Subject: RE: EP/39/22/PL 29 Tamarisk Way
Importance: High

Subject: EP/39/22/PL 29 Tamarisk Way

Figure 2 - Proposed Northern Elevation

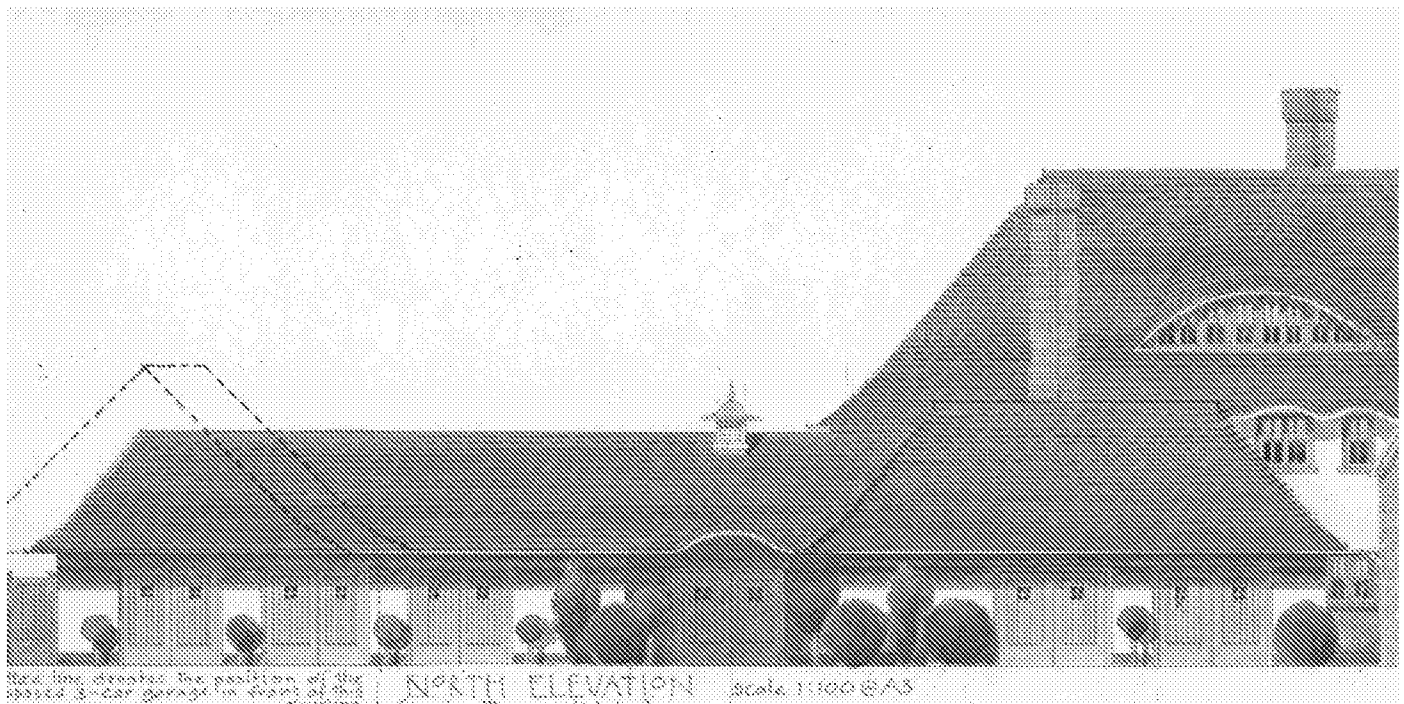
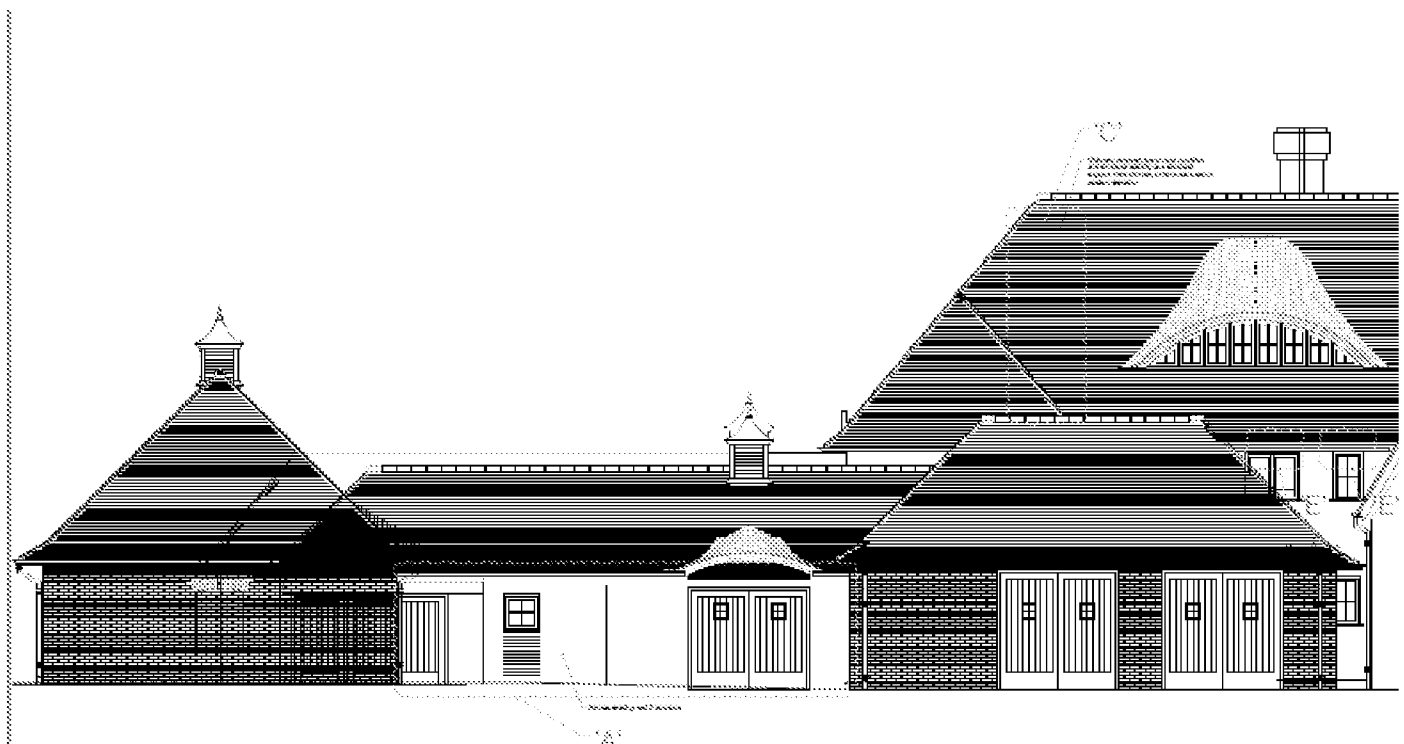
The aspects which we believe you to be referring to are those sections above the windows, identified as 'E' on the proposed plans. Please could you confirm? If so then, as you have acknowledged, we would not be able to provide these design features due to the proposed rain water guttering. This has been explored and unfortunately there is not another method available in providing the guttering without detriment to the visual impact of the building which is considered to be more significant than the loss of the design features to these windows. We would therefore suggest that there is not an alternative method to install the guttering.

Apologies for the delayed response relating to the above application which was recently transferred over to me. Having now looked through the application documentation and recent correspondence with Obafemi and having had the chance to discuss the case with Juan, we feel that the loss of the eyebrow dormers would have a detrimental impact to the character of the building.

As a Locally Listed Building any alterations are expected to relate sensitively and respect the architectural interest as per Policy HER DM2 of the ALP. As stated above the eyebrow windows form part of the character and as such we seek to preserve these features of interest. I understand that there are difficulties relating to the rainwater gear however, technical matters of design are not a concern for planning, and we would request you seek an alternative method to install the guttering whilst maintaining the special architectural features of the building.

The browed eaves were not structural and were part of the thatch roof which the original consent gained permission to remove. The browed eaves are not supported by timber substructure and we therefore cannot replicate such minor protrusions within the tiled roof.

Although the proposed plans seek to remove the browed eaves above the windows, the scheme seeks to retain the eyebrow dormers as previously approved at roof height and ground floor. The eyebrow dormers are considered to

be the special architectural features of the building which are capable of being delivered. Unfortunately it is not possible to deliver the browed eaves as part of the tiled roof. This was only possible with the thatch roof.
